The title of Article 4 of 18 AAC 75 is changed to read:

**Article 4. Oil Discharge Prevention and Contingency Plans  
[AND NONTANK VESSEL PLANS]**

**Figure 1. Regional Master Contingency Plan Boundaries (18 AAC 75.495)**

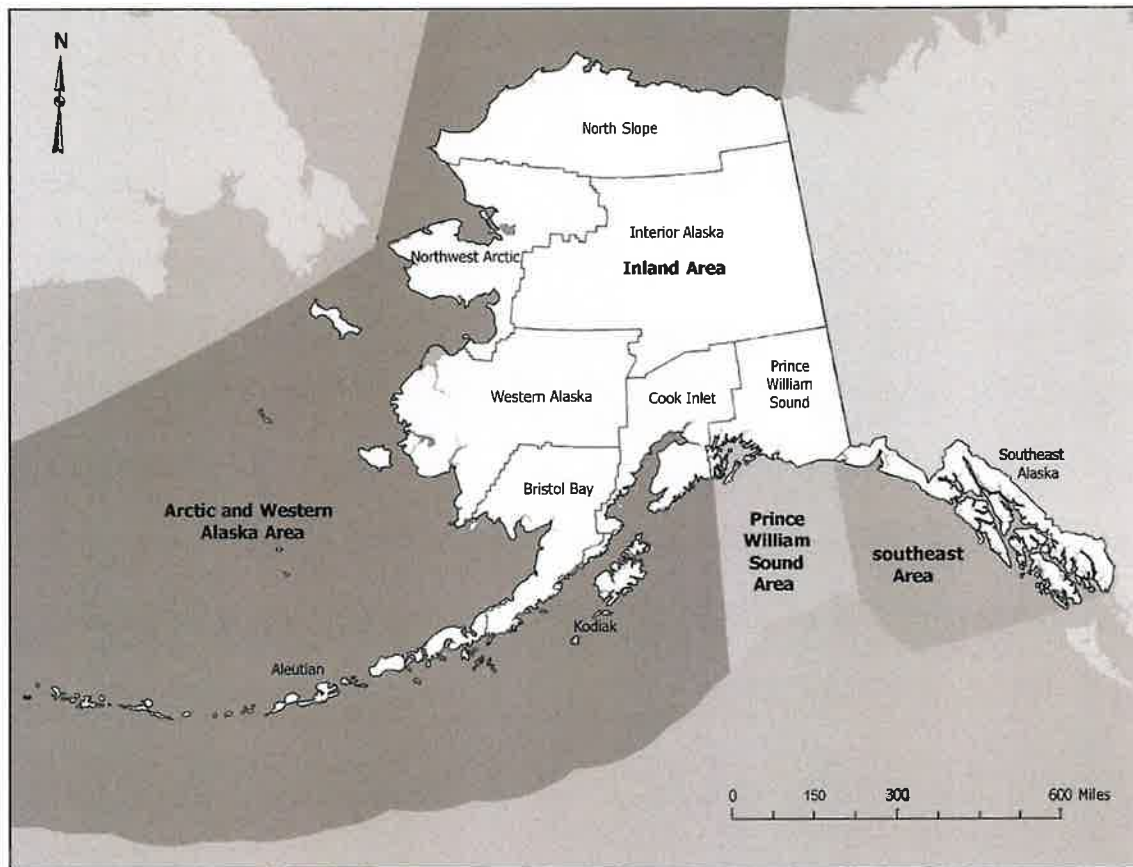
18 AAC 75.495 is amended by updating Figure 1:

**Figure 2. Regional Response Operations Plan Boundaries (18 AAC 75.496)**

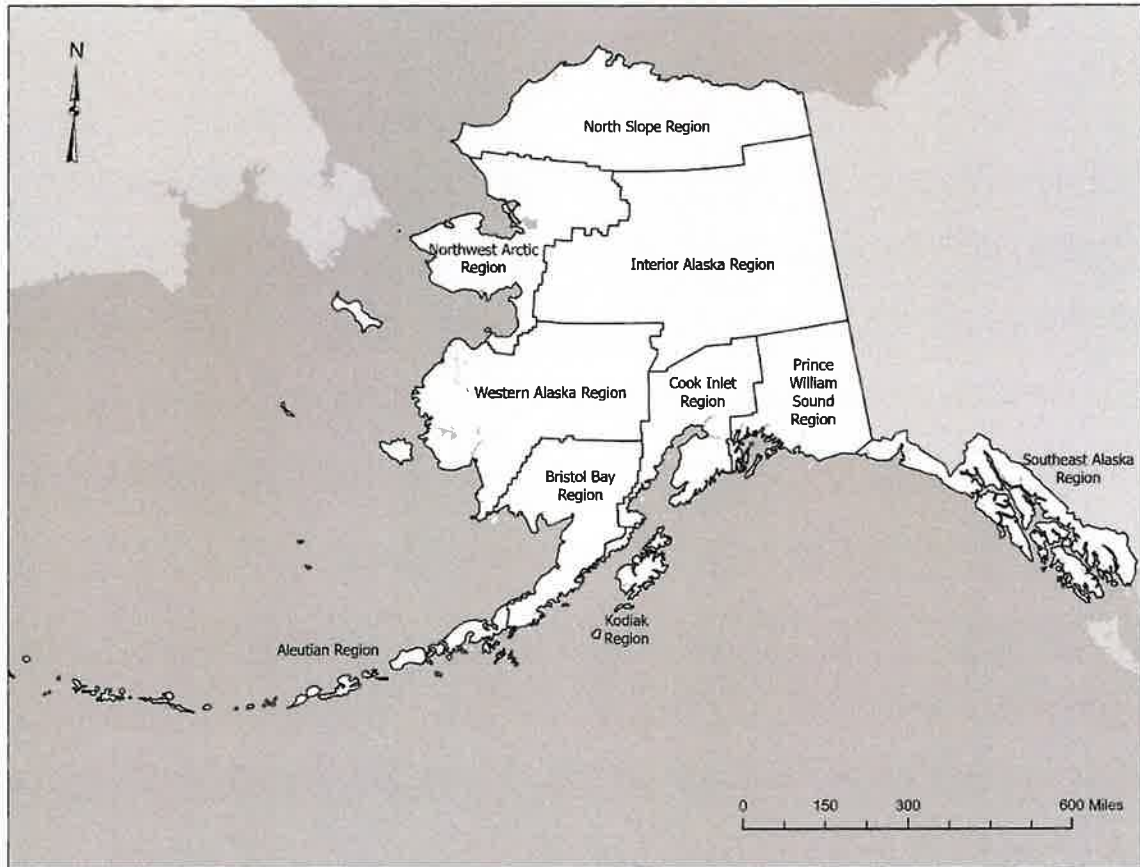
18 AAC 75.496 is amended by updating Figure 2:
